RE: Broadstone Highlands Hotel Block Conceptual Grading and Drainage Plan Engineer's Stamp Date: 2/12/18 Hydrology File: K15D034B

Re: Highlands Hotel / Hydrology File K15D034B

Enclosed for your review and comment is a re-submittal of the Highlands Hotel Conceptual Grading & Drainage Plan. Please see the responses to your comments dated 02/12/18 below:

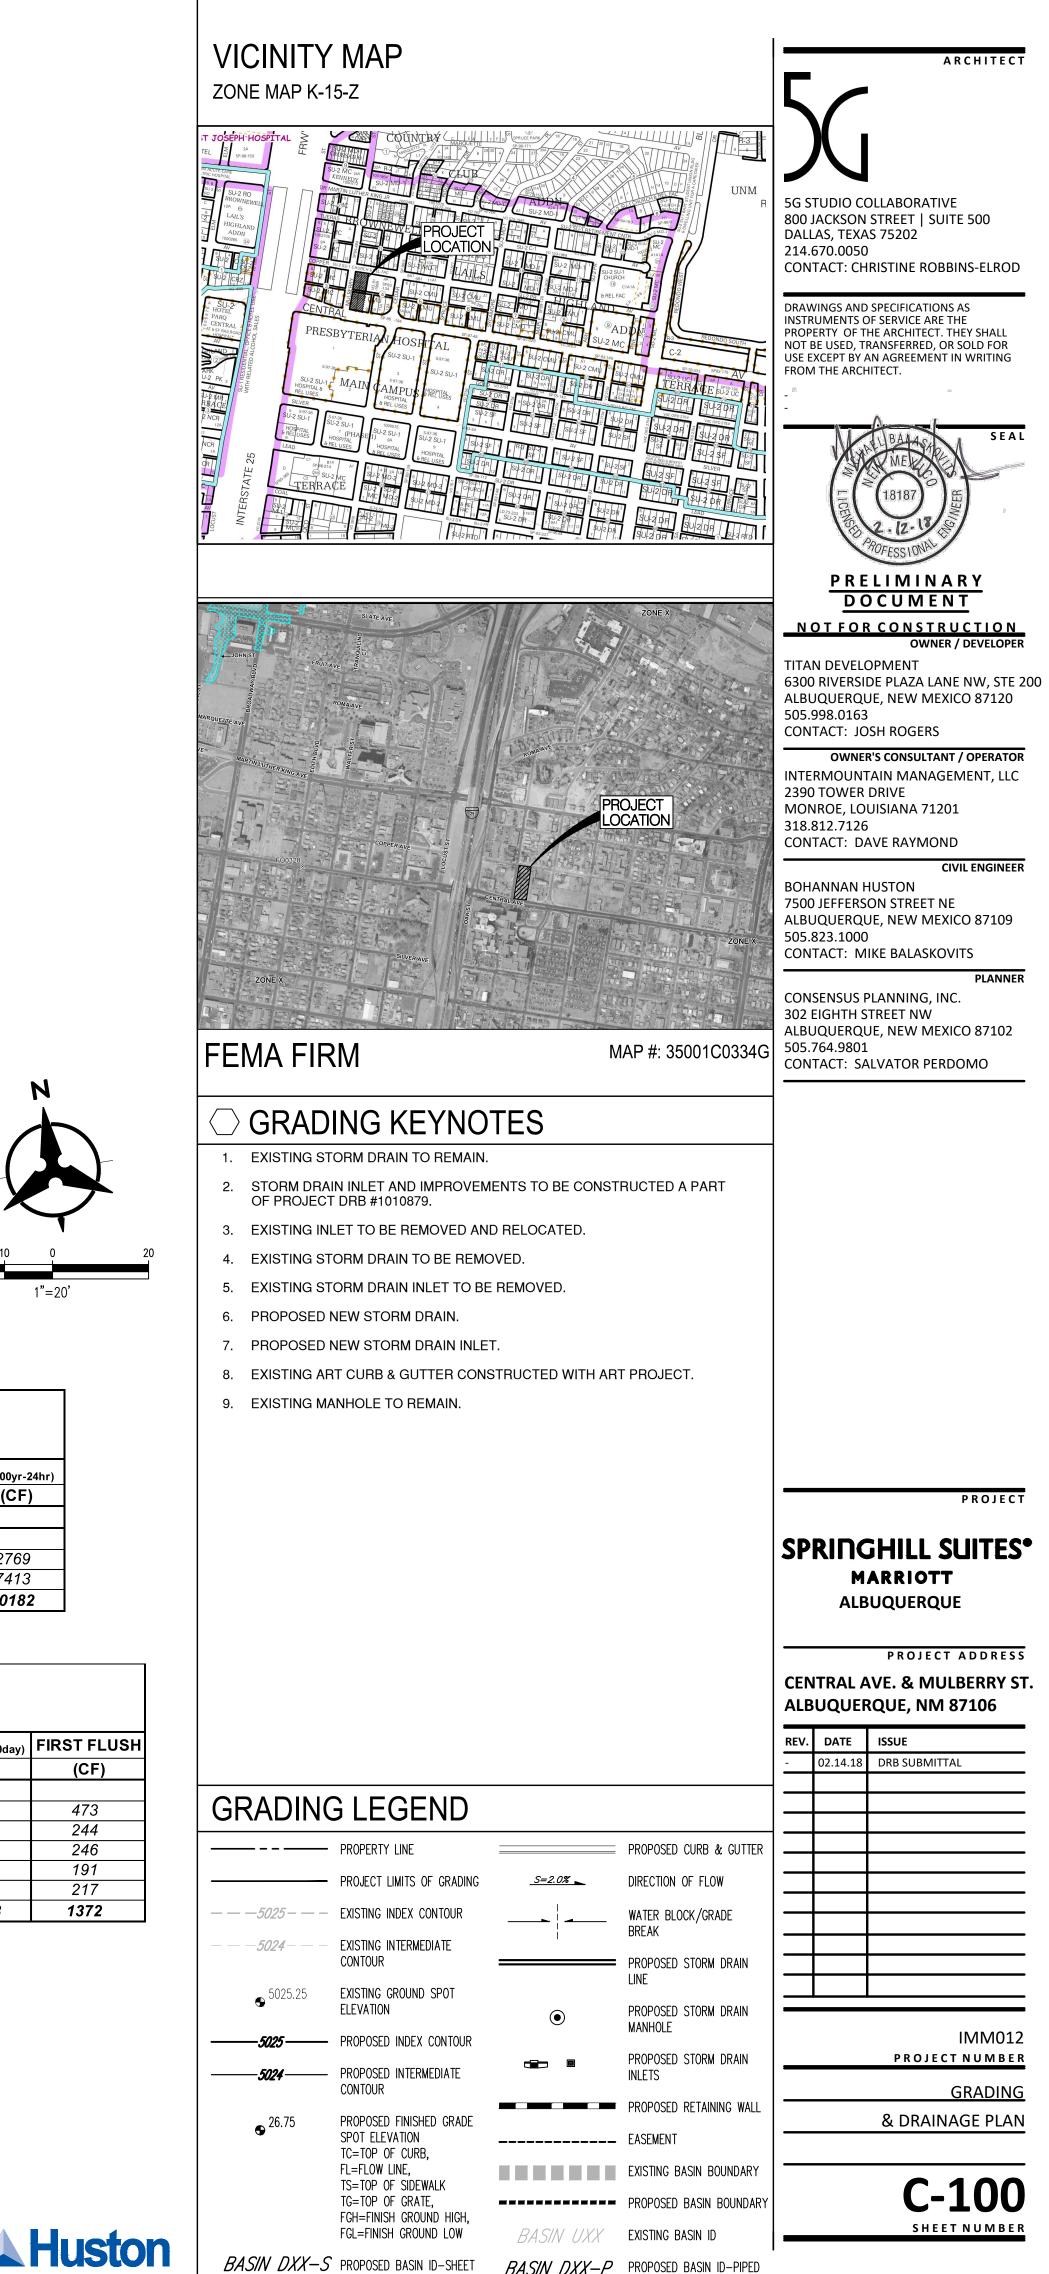
PO Box 1293 Prior to Building Permit a detailed Grading and Drainage Plan will be required. This plan will need to callout the two inlet replacements as private infrastructure (not public); additional comments can also be reasonably expected.

1. At the intersection of vacated Mulberry and the alley, provide a clearly defined waterblock, 1' high, to prevent flows from leaving Mulberry and flowing west down the alley.

2. Clarify the work to be performed on the public and private storm drain at the intersection of vacated Mulberry and the alley. Currently there is a public manhole in the street and a public type-D inlet in the flowline. Will the manhole be replaced with a new inlet, with the street graded towards it? The new inlet does not appear to be placed where it will intercept flows.

3. Provide additional flowline elevations at the intersection of vacated Mulberry and Central. Is there anything here to keep flows from entering your site from Central? *Response:* Additional flowline elevations have been added along Mulberry and Central. No water block was provided with the construction of the returns with the ART project. The existing flow today heads north onto Mulberry.

Response: A water block will be provided at the intersection of Mulberry and the alley to prevent flows from heading west into the alley.

Response: The existing public manhole and public type-D inlet along the flowline which are currently there today are intended to remain. The inlet will be replaced in the same location with a new type-D inlet.
